# Development Review Committee

## Staff Report

<b>Case No:</b>	15DEVPLAN1146
<b>Project Name:</b>	VU Connection
<b>Location:</b>	213, 217, 219, 221, 227, & 229 East Breckinridge Street
<b>Owner(s):</b>	George Stinson, VOEB & TMTS LLC
<b>Applicant:</b>	Owner
<b>Representative:</b>	John Miller, Miller Wihry
<b>Project Area/Size:</b>	1.11 acres
<b>Jurisdiction:</b>	Louisville Metro
<b>Council District:</b>	4 – David Tandy
<b>Case Manager:</b>	Sherie' Long, Landscape Architect

Category 3 Development Plan  
**VU connection**  
 229 E BRECKINRIDGE STREET, LOUISVILLE, KY 40203  
 Includes: 213, 217, 219, 221, 225, 227, & 229 E BRECKINRIDGE STREET  
 DB 10051 P 188 TAX BLOCK #300 PARCELS 9, 10, 11  
 DB 10258 P 68 TAX BLOCK #300 PARCELS 12, 13, 14

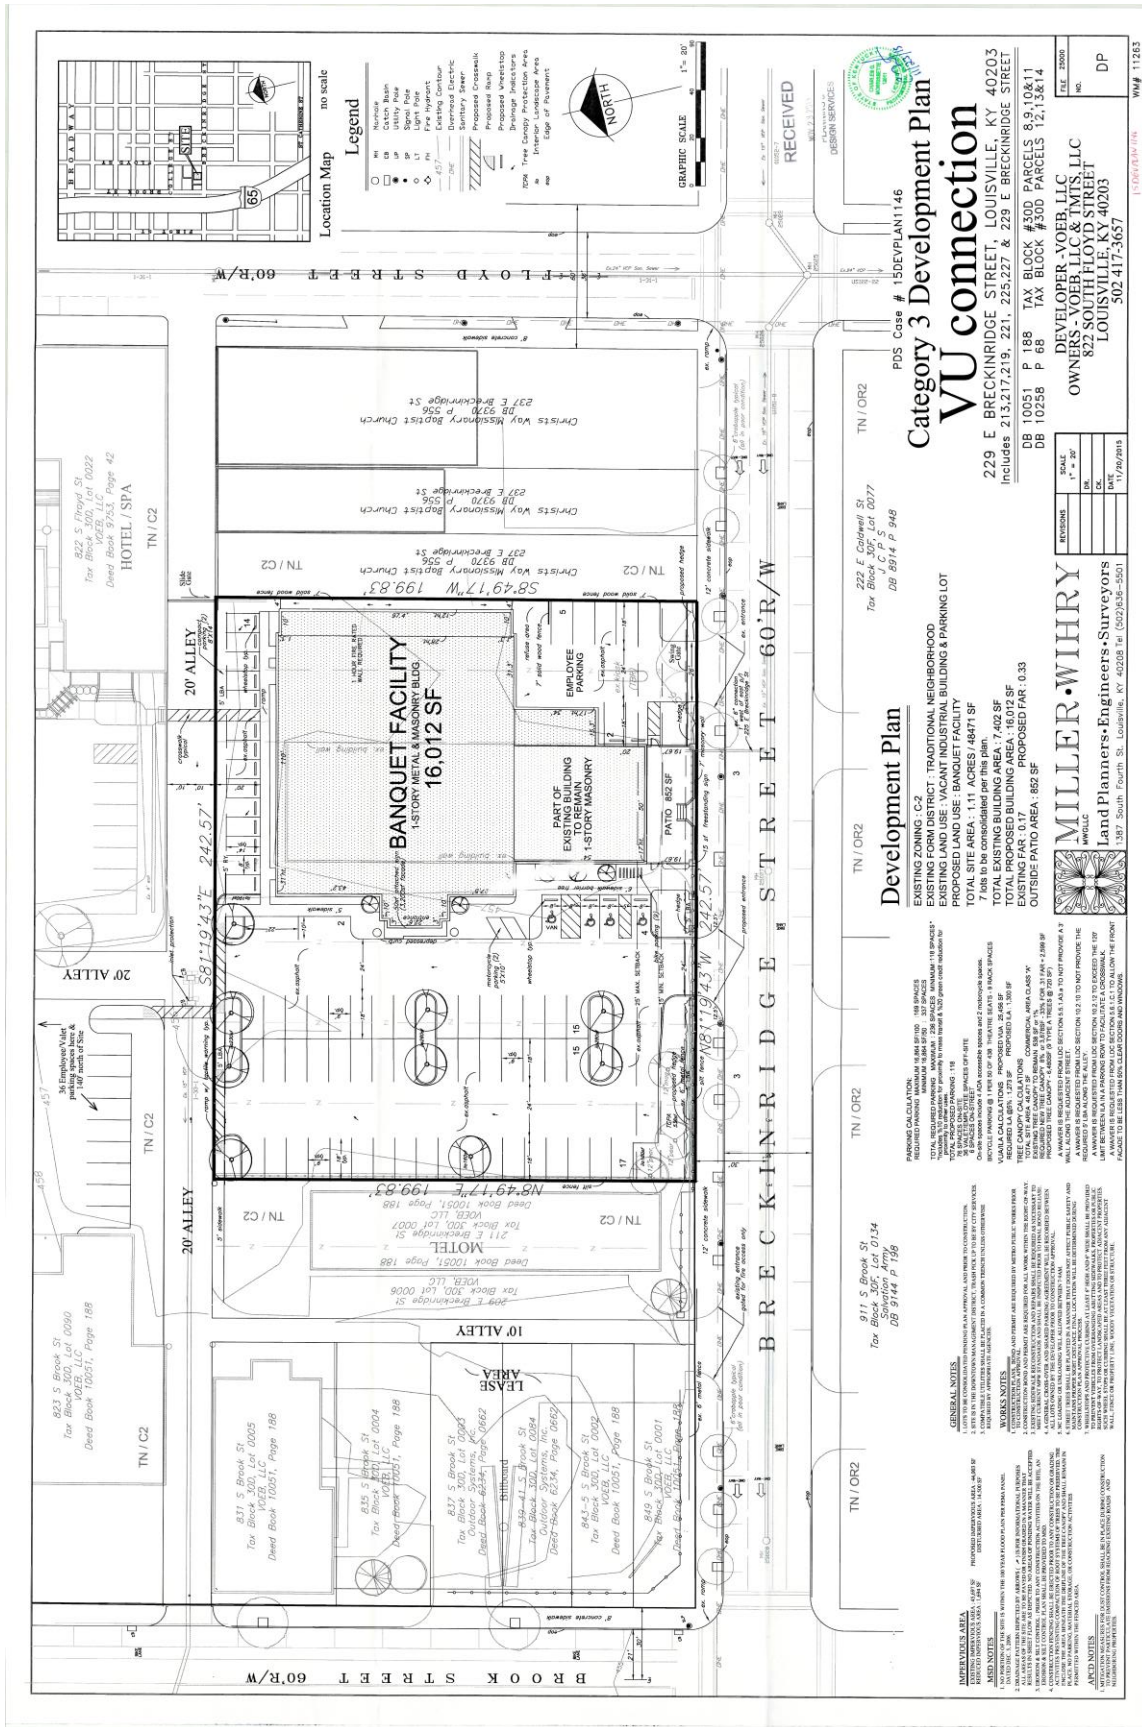
STAFF: Buildings and parking lots will meet all required setbacks. The overall site design and land uses are compatible with the existing and future development of the area. Appropriate landscape buffering and screening will be provided to screen adjacent properties and roadways, except for the waivers being requested to not provide the screening and interior landscape area in the rear parking area adjacent to the alley.

STAFF: The waiver will not adversely affect adjacent property owners since the proposal will be adding screen plantings in front of the proposed parking lot to reduce impact. Plus existing trees are located between the building and the street which also reduces the impact.

STAFF: The waiver will not adversely affect adjacent property owners since screen plantings and the 6' aluminum fence are being provided instead of the 3' screen wall.

STAFF: The waiver will not adversely affect adjacent property owners since only the portion of the buffer not being provided is located where the parking spaces are being accessed by the alley. The remainder of the VUA LBA will be provided between the sidewalk and the parking stalls of the larger parking area to the west of the proposed building.

STAFF: The waiver will not adversely affect adjacent property owners since only the ILA area are not being provided in the parking area at the rear of the building. The remainder of the ILA's will be provided in the larger parking area to the west of the proposed building.

STAFF: The extent of waiver of the regulation is not the minimum necessary to afford relief to the applicant since ILA areas with tree plantings could be incorporated along the rear of the building by eliminating one or two parking spaces.

Based upon the information in the staff report, the analysis of the standards of review support the request to grant waivers 1, 2, 3, and 5; and the Category 3 Development Plan. However, waiver 4, the ILA area, could be provided by eliminating one or two parking spaces along the rear of the building to provide green space and tree planting.

## BRECKENRIDGE STREET ELEVATION

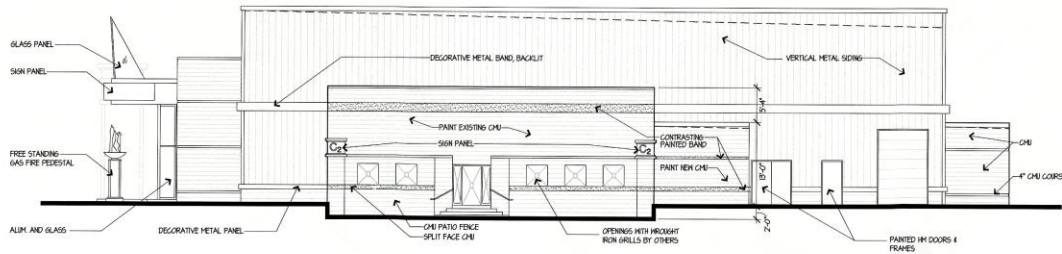
STAFF: The requested waiver will not adversely affect adjacent property owners since the applicant is providing openings at the street level which provide views into the patio area instead of providing clear glass.

STAFF: Guideline 3, policy 1 and 2 calls for the compatibility of all new development and redevelopment with the scale and site design of nearby existing development and with the pattern of development within the form district. The type of building materials may be considered as a mitigation measure and may also be considered in circumstances specified in the Land Development Code. When assessing compatibility, it is appropriate to consider the choice of building materials in the following circumstances: (1) projects involving residential infill (2) projects involving non-residential uses; and (3) when specified in the Land Development Code. The proposal is for a non-residential use. The Land Development Code provides building design standards for non-residential and mixed use buildings. The purpose of the regulation is to provide visual interest and a human scale that are representative of the form district through the use of windows, columns, pilasters, piers, variation of material, entrances, storefront windows, and other animating features along no less than 75% and 50% clear glass and doors. The waiver will violate the comprehensive plan since openings and animated features are being provided along the front facades of the building which meets the intent of the requirement.

STAFF: The extent of the waiver of the regulation is not the minimum necessary to afford relief to the applicant since the proposal does provide animated features on the façade and opens to allow views into the patio.

STAFF: The applicant has incorporated other design measures to compensate for non-compliance with the requirements to be waived. Opening providing views into the patio are being provided instead of the clear glass and doors.
